SUBJECT: Addendum No. 3

Wentworth Springs Road at Gerle Creek – Bridge Replacement

Contract No. PW 11-30573, CIP No. 77118

SHEET S-2 7 of 13 77118

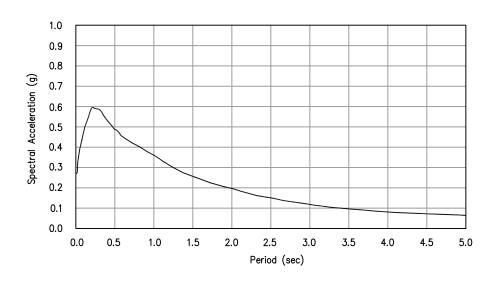
ITEM NO.	LOCATION, PAGE OR DRAWING NO.	DESCRIPTION OF CHANGE
3.01	Plan Sheet S-2 and SP-76	Bidders are instructed to replace Plan Sheet 7 of 13 (S-2) with revised Plan Sheet 7 of 13 (S-2) attached to this Addendum.
		Revise the last bullet under "Superstructure Loading" in Section 10-1.19 "Pre-fabricated Steel Truss Bridge" on SP-76 of the special provisions to read as follows:  "Seismic loads at each abutment = 90 kips (longitudinal); and 60 kips (transverse)."
